Savannah (SC 170, US 17) and Pinckney Island (US 278) National Wildlife Refuges

Road Safety Audit

Beaufort and Jasper Counties, South Carolina

March 5-6, 2008

Figure 1.1 General Study Area of Pinckney Island (US-278)

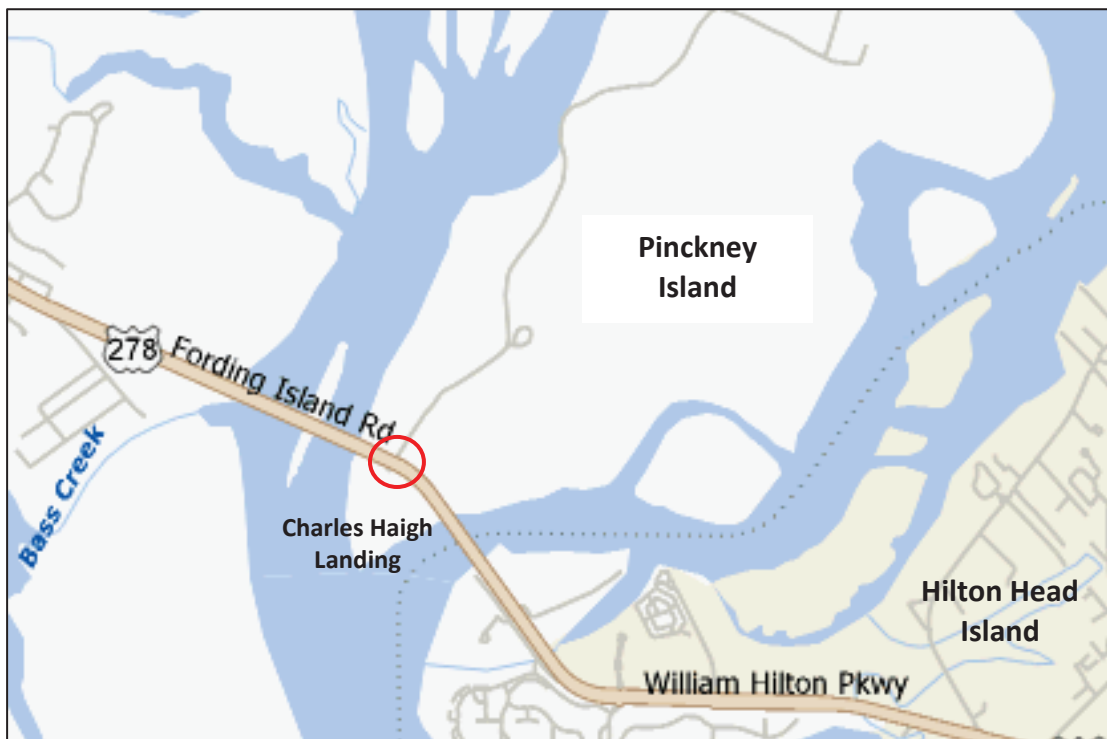
The objective of this study was to complete a road safety audit (RSA) for Savannah and Pinckney Island National Wildlife Refuges (NWR). The Pinckney Island study area is located along US-278 in Beaufort County, South Carolina at the entrance to the refuge as shown in Figure 1.1. The Savannah NWR study area is located near the junction of US-17 and SC-170 in Jasper County, South Carolina as shown in Figure 1.2. More specifically, the Savannah NWR study area included three locations, 1) the entrance to the Savannah NWR maintenance facility, 2) the access points to the Laurel Hill Wildlife Drive, and 3) the entrance to the proposed visitor center.
